O.P.W Ref No. 227-2026

Re: Case Number: ACP-323900-25, Proposed upgrades to Limerick Wastewater Treatment Plant and Regional Bioresource Centre, Bunlicky, County Limerick.

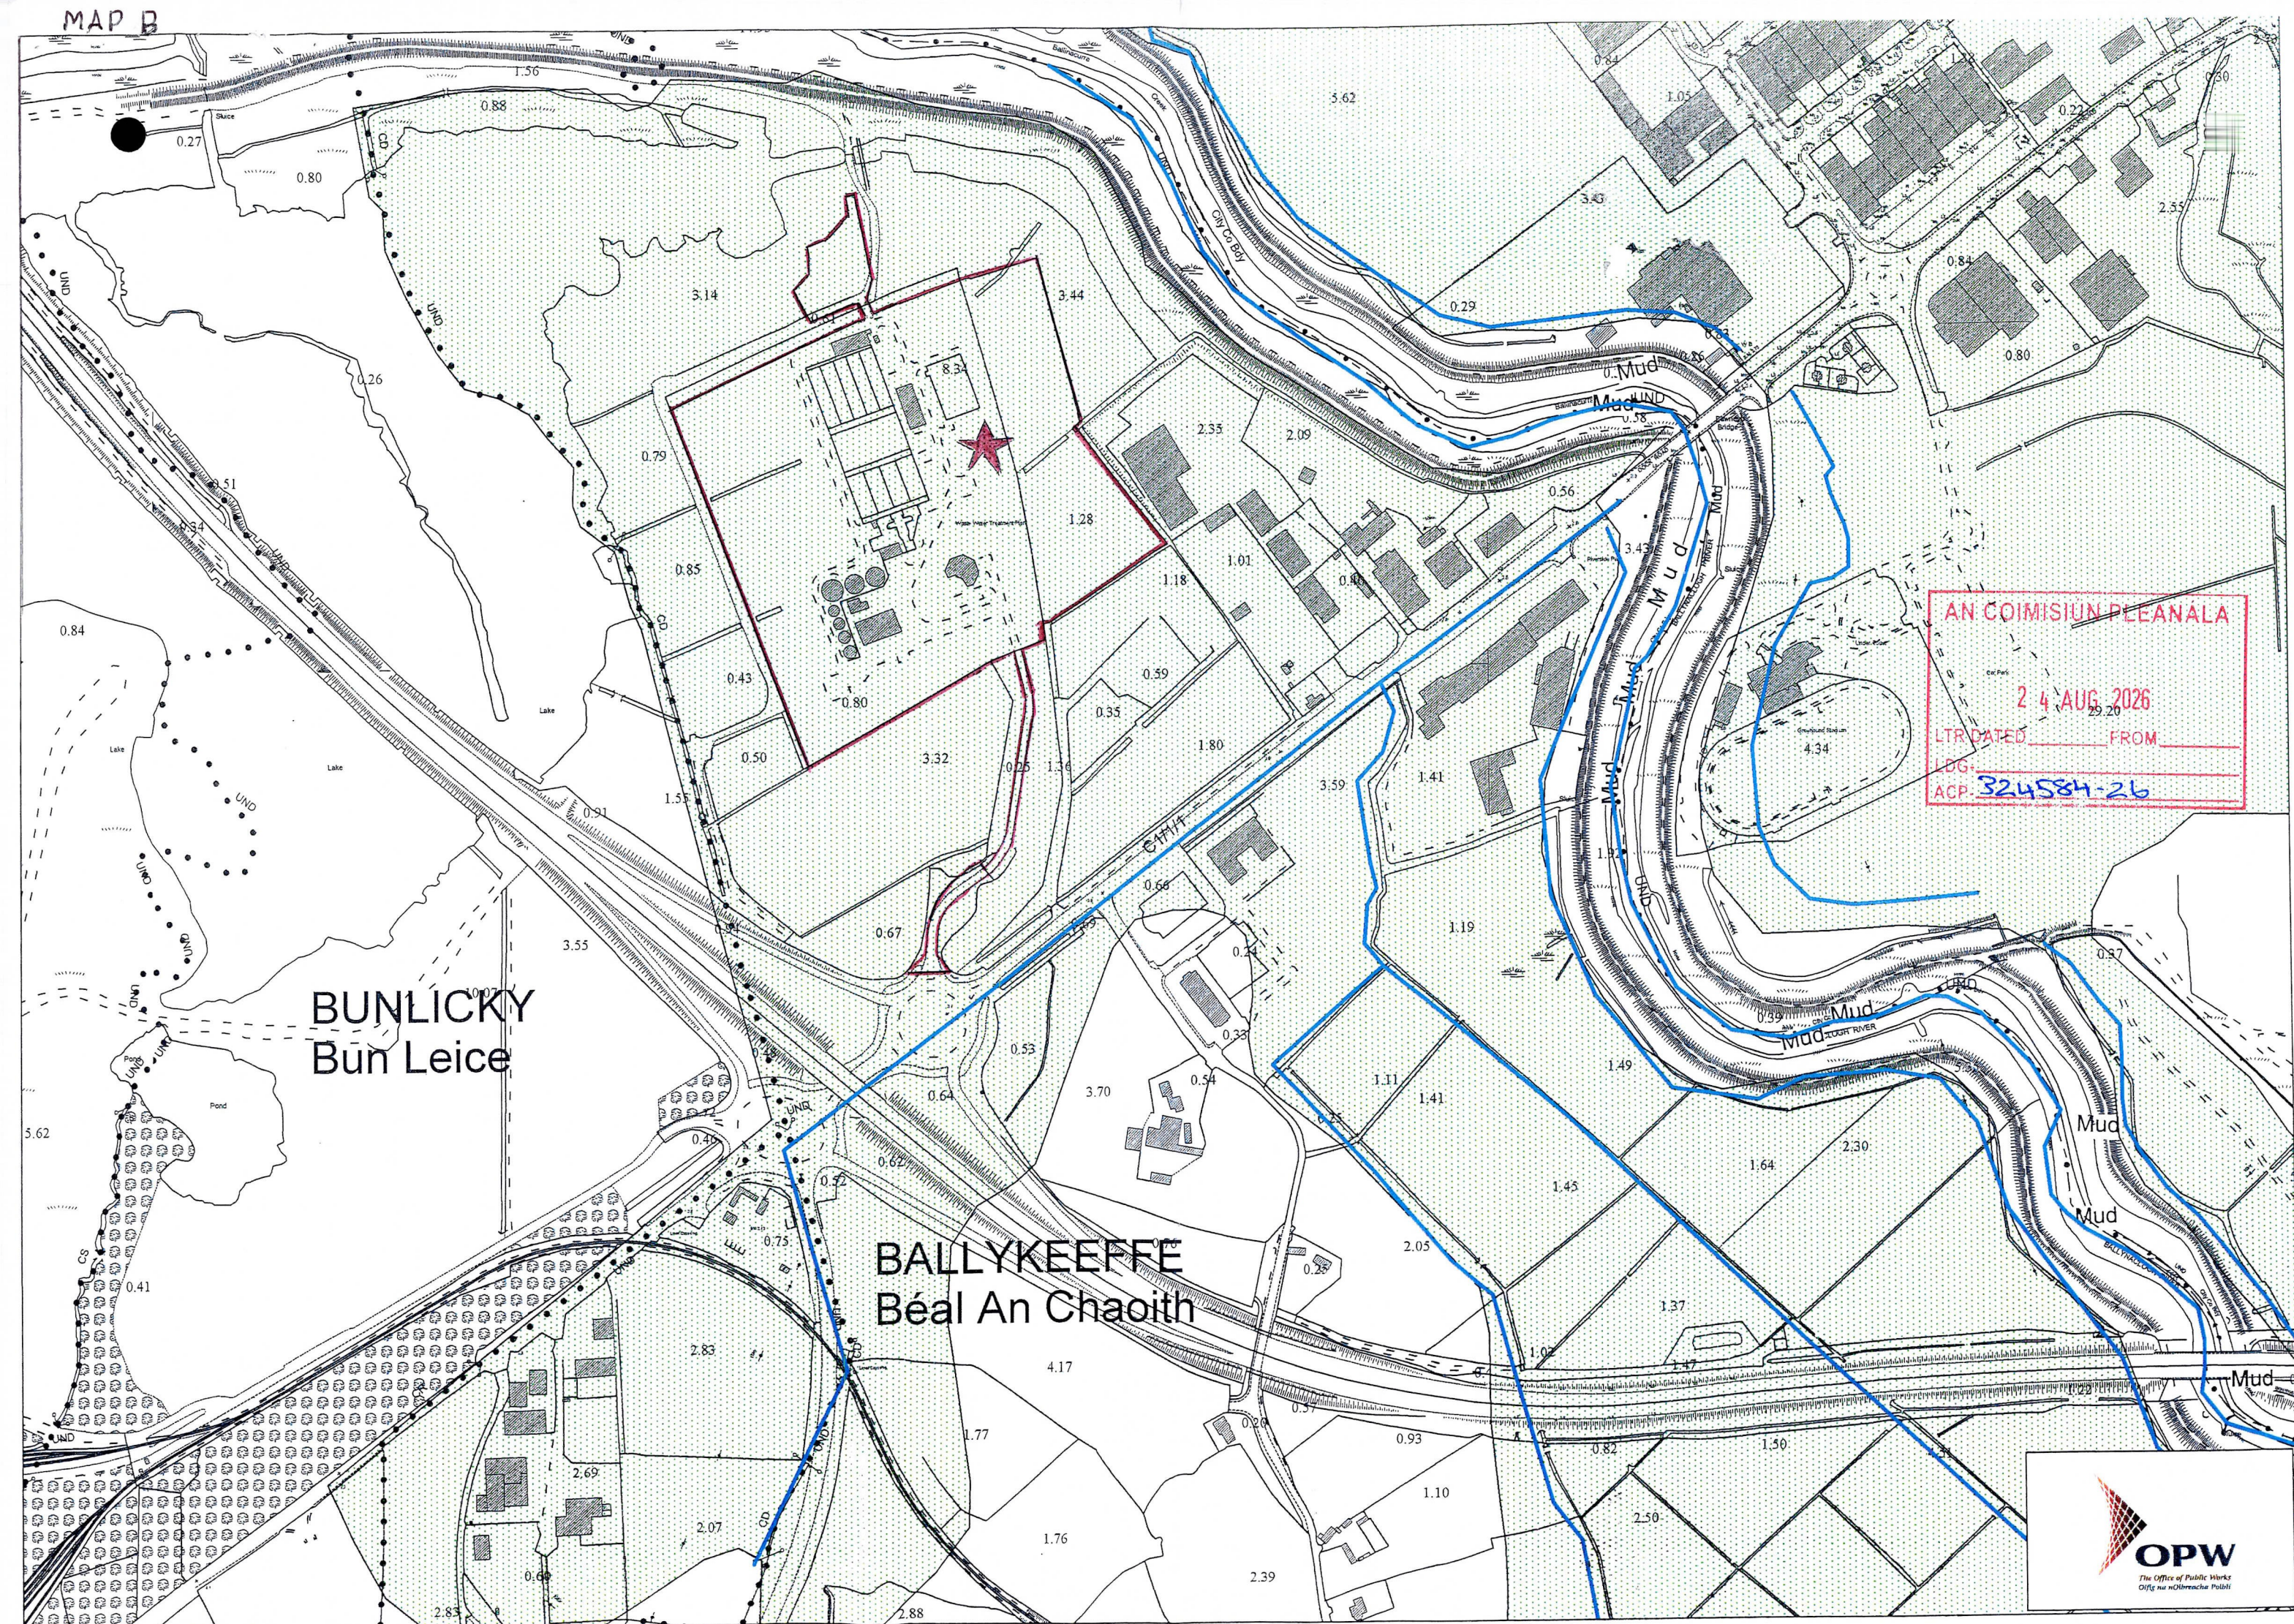
The site on Map A which contains Corcanree Pumping station is bounded on the Northern side by OPW Channel D1 of the Polefield Arterial Drainage Scheme which is under the auspices of this office. In order to gain access for the purpose of maintaining this channel, the Office of Public Works requests that the following be included as a Condition of any Grant of Planning Permission.

This office would request that a 5 Metres Wide strip be retained, adjacent to the channel D1 to facilitate on-going access and maintenance requirements. This strip should be unimpeded to mechanical plant and should not be landscaped, paved or otherwise developed in a manner that would impede or prevent access to said channel.

The Site of the proposed development, falls within the area deemed to benefit from drainage by Channel No. D1 of the Polefield Arterial Drainage Scheme and as a result is subject to an increased flood risk. The Polefield Arterial Drainage Scheme was originally constructed to a standard to protect agricultural land from flooding and as such does not confer the level of immunity usually associated with residential or commercial developments. Please find attached Map A, showing "Benefiting Land" shaded in green and D1 Polefield Arterial Drainage Scheme delineated in blue.

The site on Map B showing Limerick Wastewater treatment Plant , falls within the Benefitting area and as a result is subject to an increased flood risk. The Planning Authority should satisfy themselves that due consideration is given to Flood risk at Sites shown on Map A and Map B. I would also refer you to the Office of Public Works website www.floodmaps.ie where information on historical flood events may be accessed. Furthermore additional Flood information is available on www.floodinfo.ie
